ITEM # 2.0

PRELIMINARY & FINAL PLAT APPROVAL:

Crystal Estates Phase IV Section 1 Subdivision
Being a 7.489-acre parcel of land, out of Lot 27-1,
West Addition to Sharyland
R-2
Developer: DG & GG Investments, LLC
Engineer: Ever Engineering, LLC

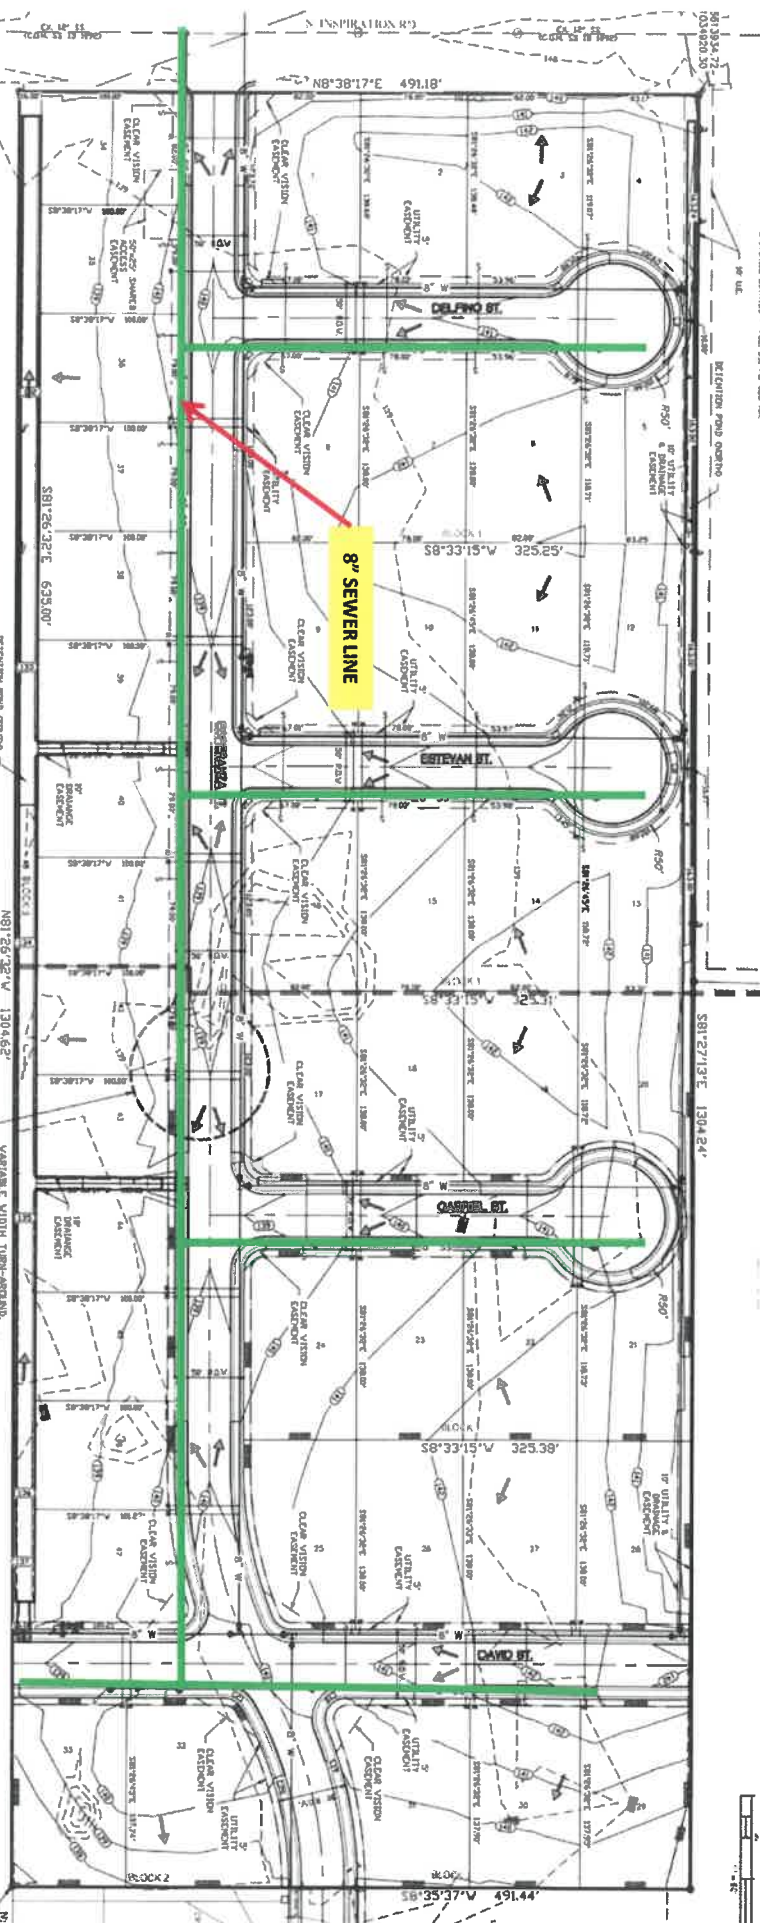
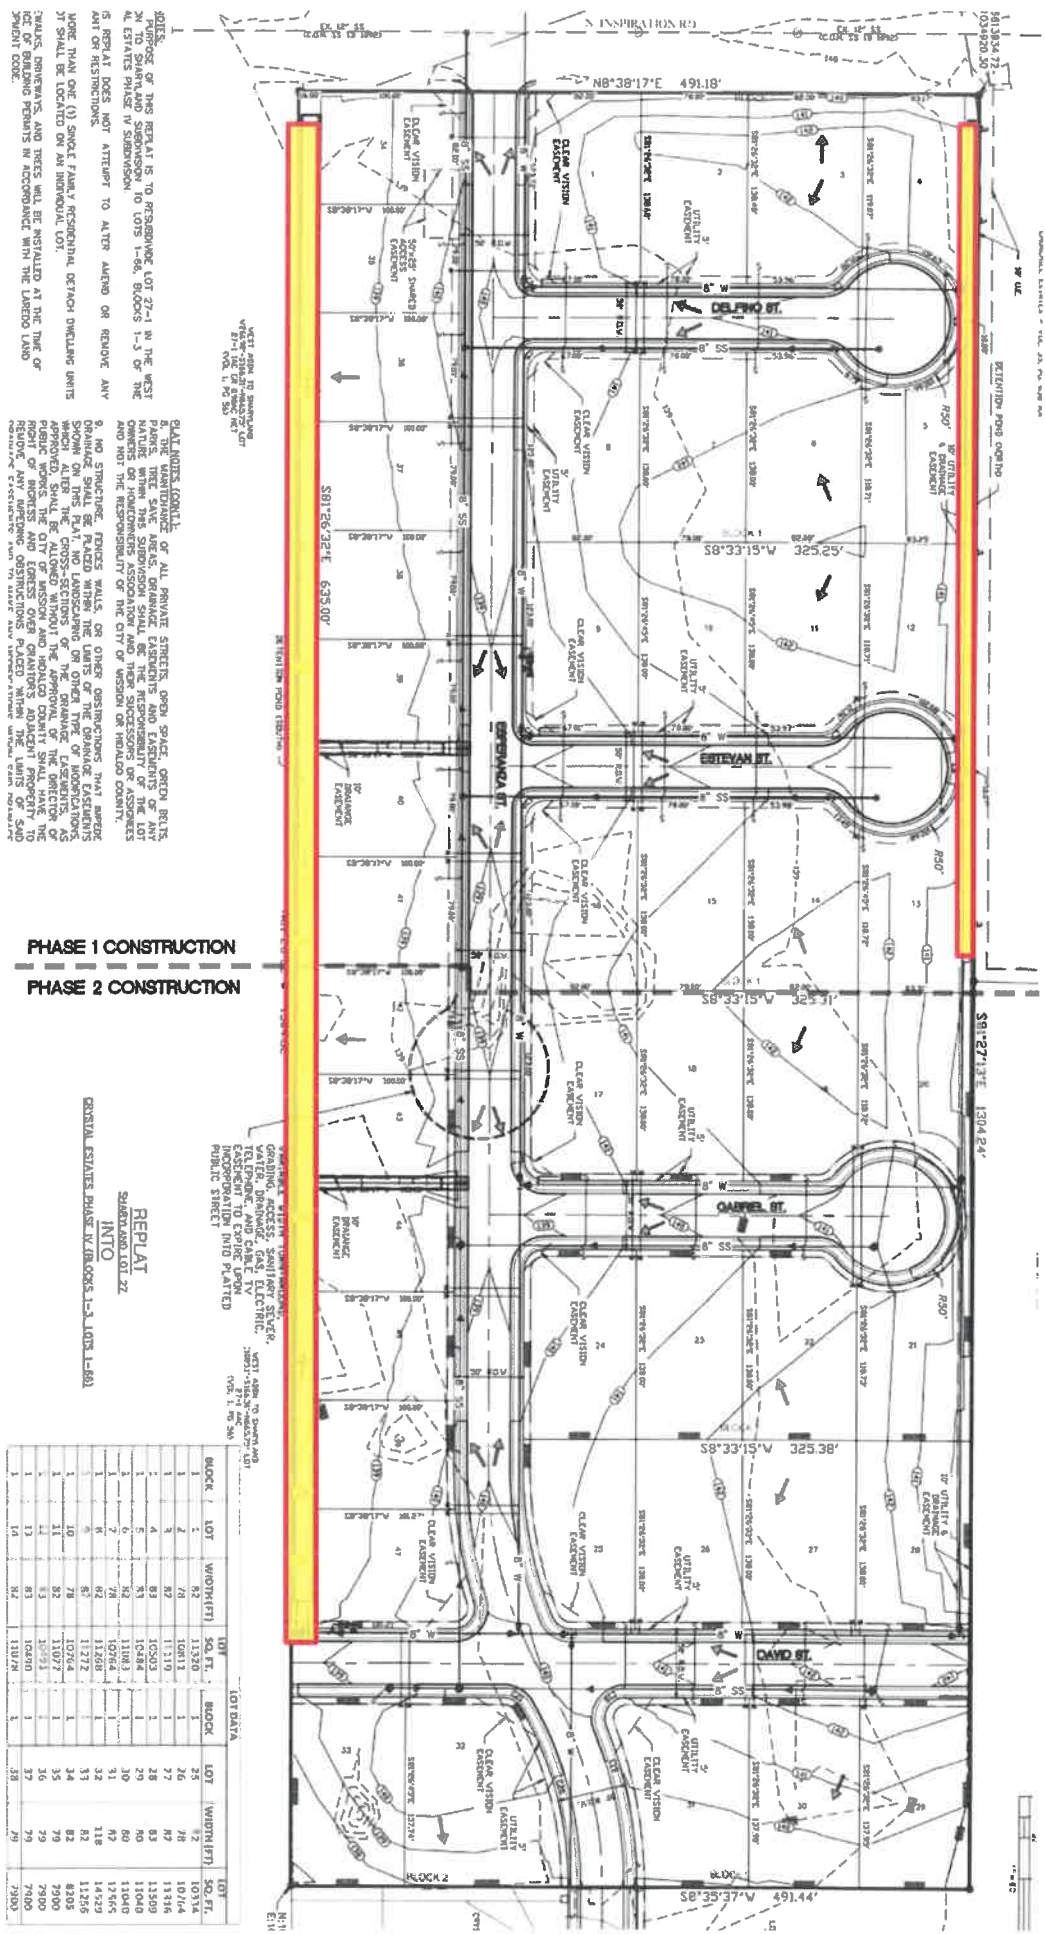
The developer is requesting to change the following street names:
Estevan St. to Britney St. / Gabriel St. to Bailey St.

1. Water District Exclusion
2. Conveyance or Payment of Water Rights/Fee
3. Denial of the requested variance to use suggested street names requested by the owner and keep the existing City's continued and aligned street names as noted on the Code of Ordinances / Chapter 98 - SUBDIVISIONS, Sec. 98-134. - Streets. (n) Street names.
